NOTICE OF NON-PERFORMANCE

Pursuant to Government Code section 15472, et seq, the Office of Energy Infrastructure Safety (Energy Safety) has conducted an inspection of work completed by Southern California Edison Company (SCE) in accordance with its 2026 Wildfire Mitigation Plan (WMP) and determined the existence of non-performance requiring correction. Energy Safety therefore issues SCE a Notice of Non-Performance (NON), identifying non-performance with its approved WMP.

INSPECTION REPORT

Deficiency #	Structure ID	Grid Hardening ID	Lat/Long	HFTD	Initiative Number	Severity	Deficiency Description
Deficiency 1	4729770E	413994354-4729770E	34.330353083056, -118.340607258323	Tier 3	8.3.1 Distribution High Fire Risk-Informed (HFRI) Inspections - Ground and Aerial (IN-1.1)	Minor	Failure to remediate the condition of loose lightning arrestor cap

General Image 1: Overall Structure

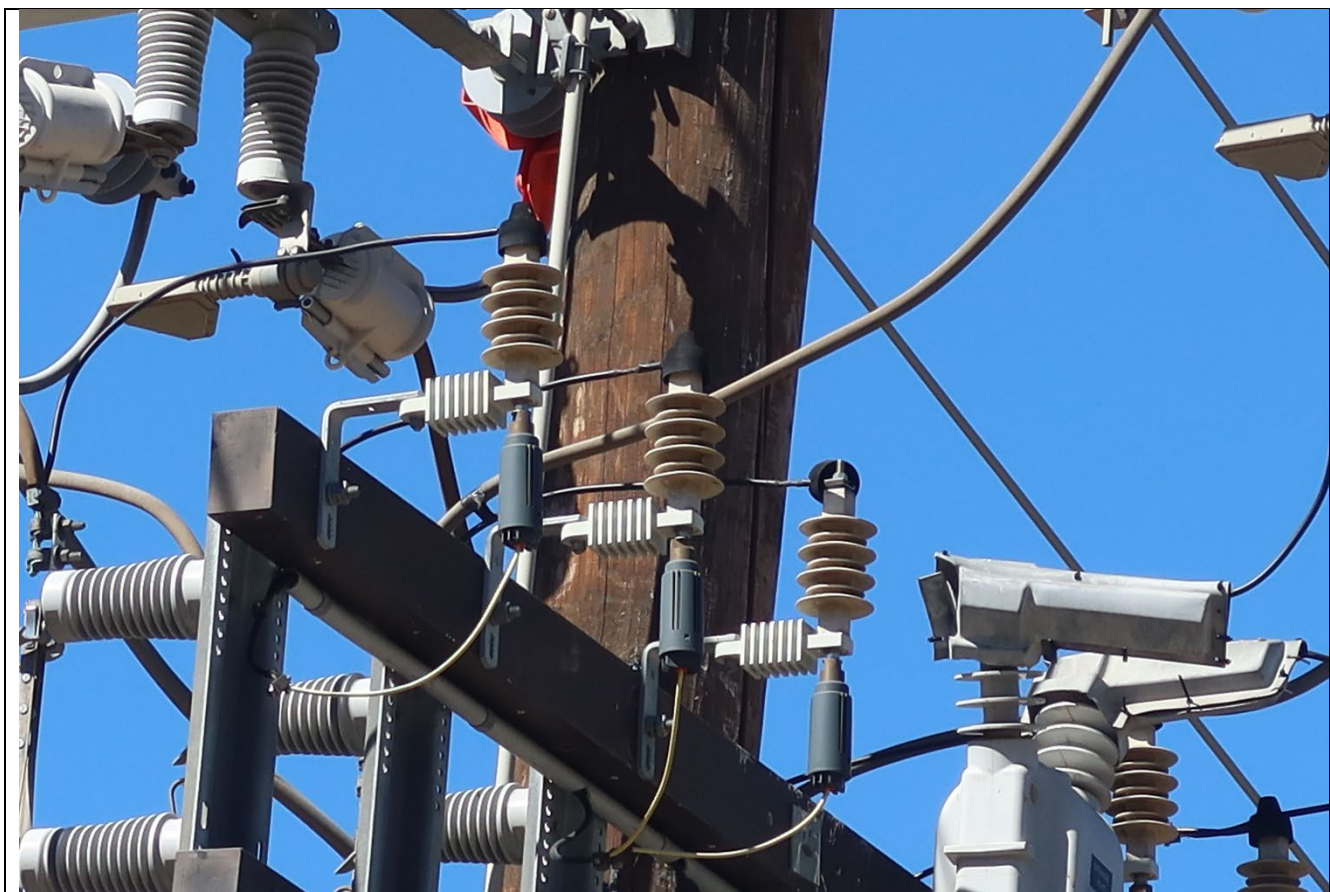
In the 2026 Q1 Quarterly Data Report Submission, Southern California Edison Company reported that work on Distribution Remediation was completed at Structure ID 4729770E, Grid Hardening ID 413994354-4729770E near San Fernando, CA, at coordinates 34.330353083056, -118.340607258323. At this location, the inspector observed that lightning arrestor cap was loose. The inspector's observation is documented in Deficiency 1 photographs, which are attachments to this report. Photo number Asset Image 1 depicts a loose lightning arrestor cap.

1. Southern California Edison Company's 2026 WMP initiative number 8.3.1 - Distribution High Fire Risk-Informed (HFRI) Inspections work identified that the remediation of a loose lightning arrestor cap was complete at this location.
2. The lightning arrestor cap was loose.

Deficiency 1. Energy Safety observed that in implementing 2026 WMP initiative 8.3.1 – Distribution High Fire Risk-Informed (HFRI) Inspection – Ground and Aerial (IN-1.1), SCE failed to remediate the condition of loose lightning arrestor cap on Structure ID 4729770E, Grid Hardening ID 413994354-4729770E at coordinates 34.330353083056, -118.340607258323. Energy Safety considers this non-performance to be in the Minor risk category. SCE must complete a corrective action for this deficiency by 12 months from the date of this notice.¹
